April 13, 2015

**RE: Comments following review of Form 28 Centralized E&P Waste Management Facility Permit
Facility ID #436570, Pond 13 East and West
Pit Facility ID #414403 and 414404, Location ID 335849**

OXY USA WTP LP (Oxy) has received and reviewed your comments regarding the above-referenced permit application. Oxy is providing responses to the comments provided by the COGCC in the letter dated November 26, 2014:

OXY POND 13
 CONSTRUCTION DOCUMENTS
 SITE PLAN
 GARFIELD COUNTY, COLORADO
 2015

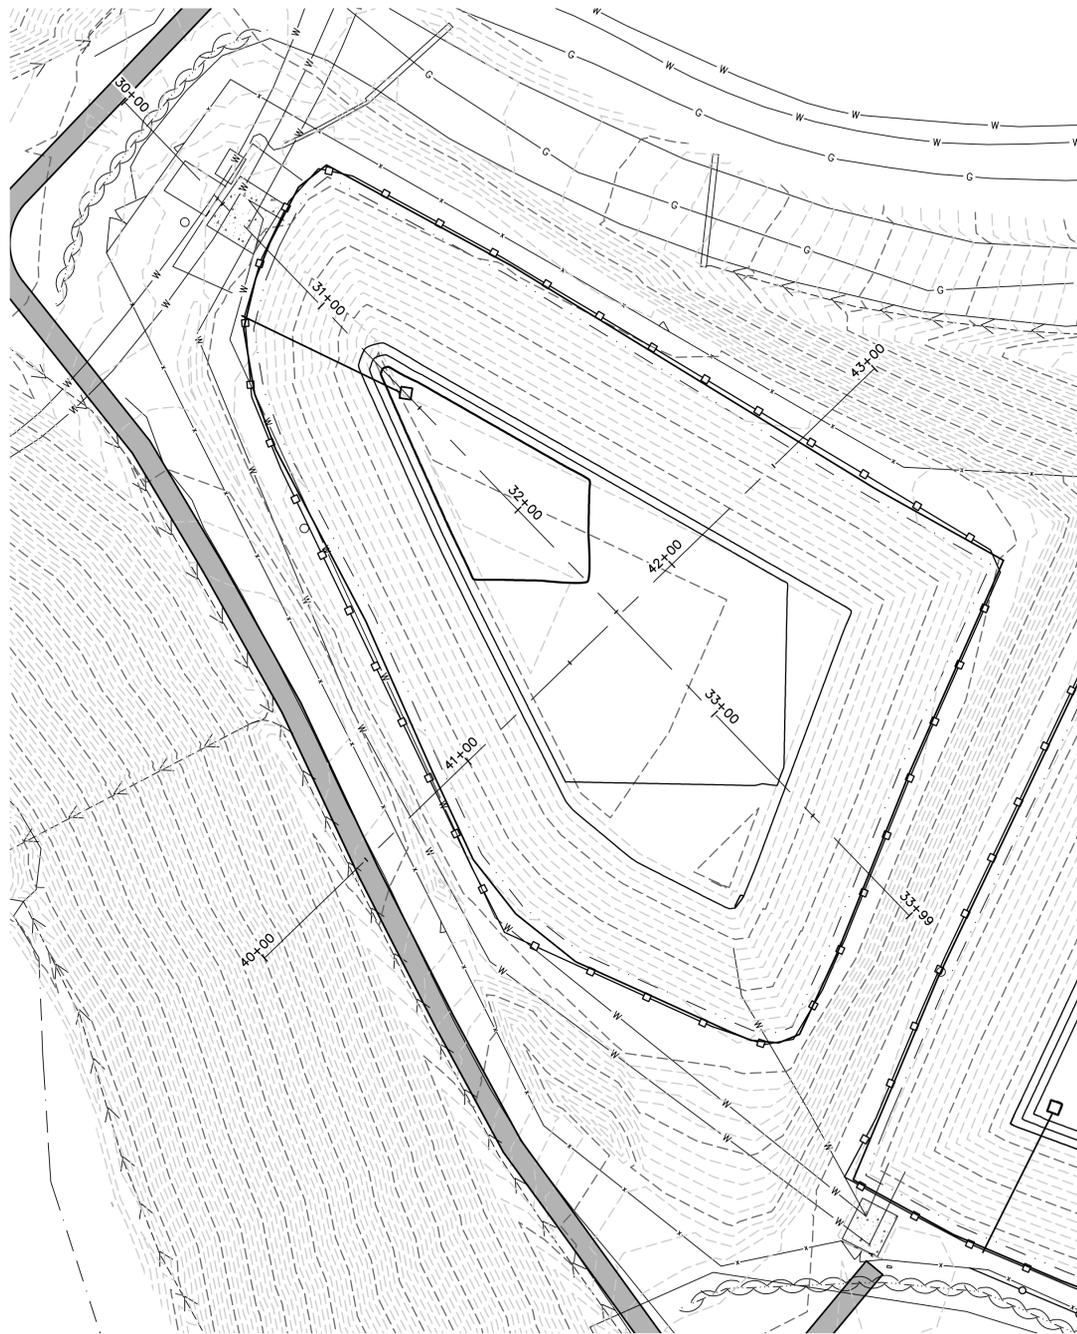
COGCC Comment – The Site Plan does not show existing grading in the existing pits or around the site. Please Clarify.

COGCC Comment – The Site Plan included with the submittal is showing existing contours at 10' intervals, with no grading contours shown across the site. A typical Site Plan should show grading contours across the site at no greater than 2' intervals, 1' would be preferred.

OXY Response – Including as an Attachment, please find the Updated Site Plan to include the existing grading in the existing pits and around the site.

Oxy Response – Including in Attachment 1 is the Updated Site Plan to include 1' grading contours throughout the site.

**OXY POND 13
CONSTRUCTION DOCUMENTS
SITE PLAN DETAILS
ANCHOR TRENCH AND LINERS
GARFIELD COUNTY, COLORADO**

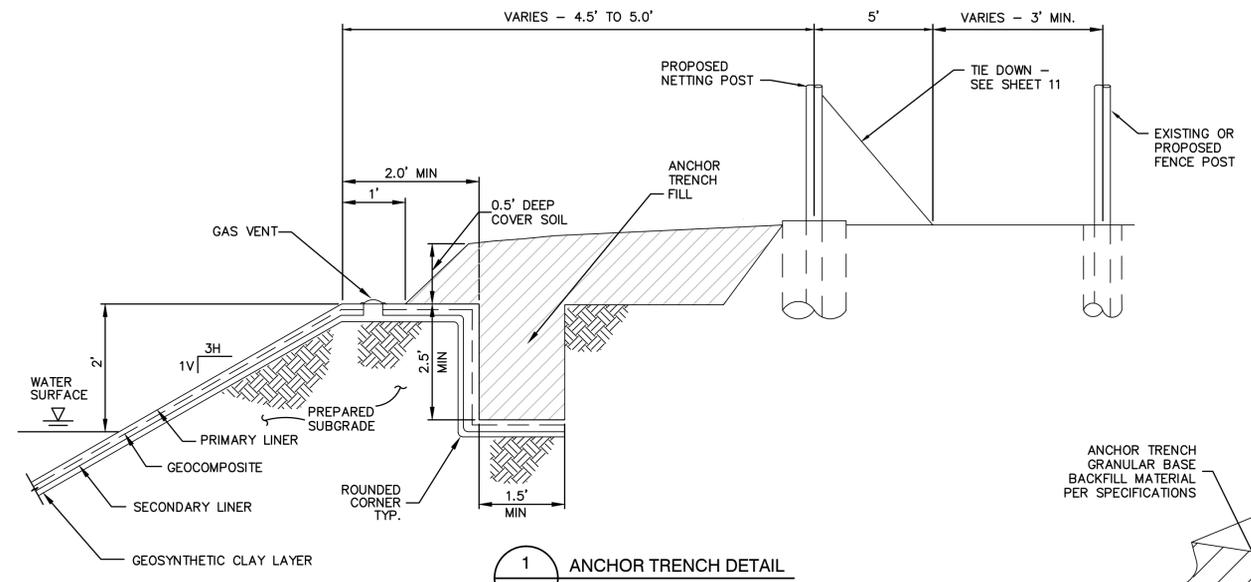
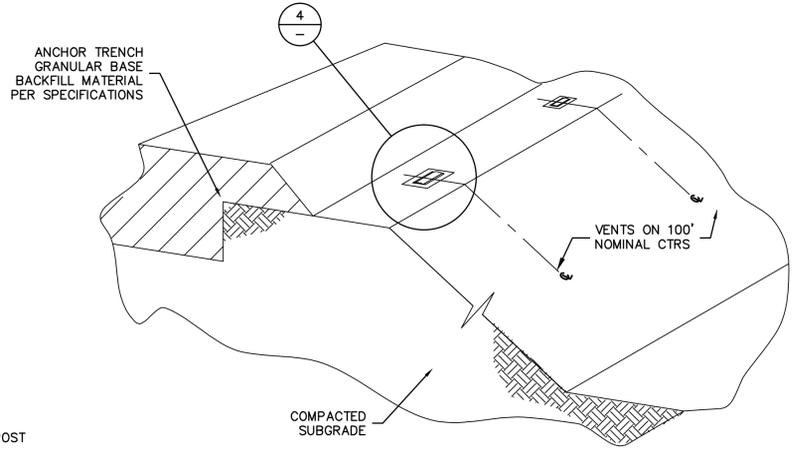
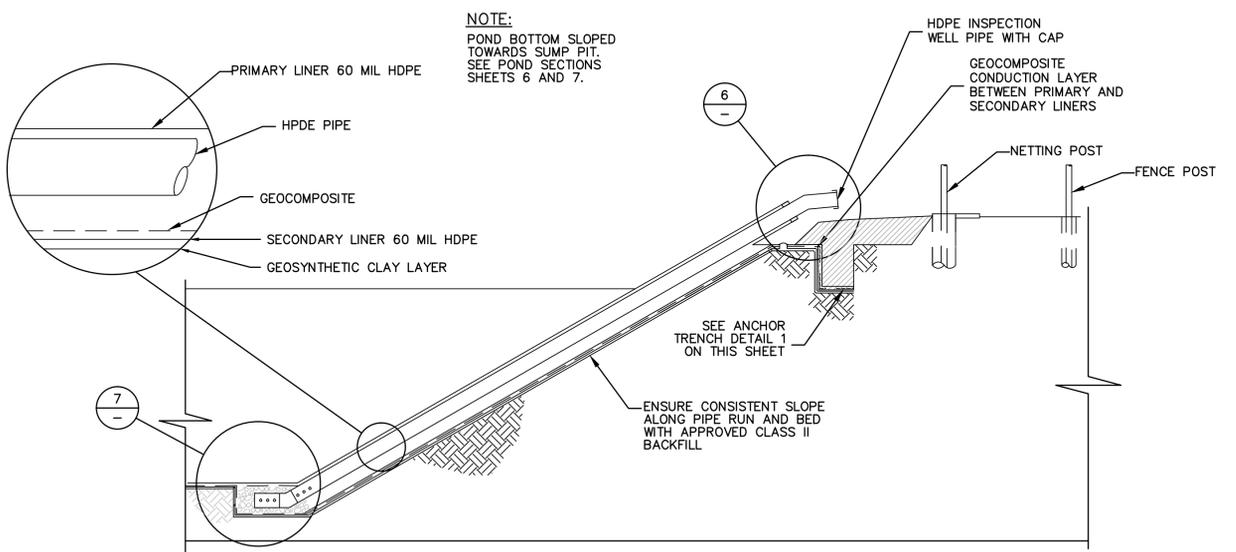
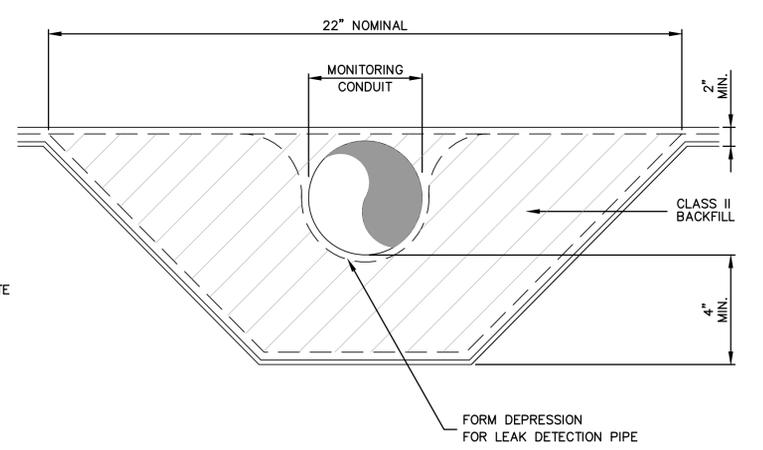
COGCC Comment – As-constructed details of the pit including liner(s), Geo-Net Conduction liner, leak detection and sump, and geo-synthetic clay liner shall be provided for review.

Oxy Response – Included as an attachment is construction drawings for the upgrade of Pond 13 to include the liner configuration, plan view and cross sections of the pit, and netting fencing details.
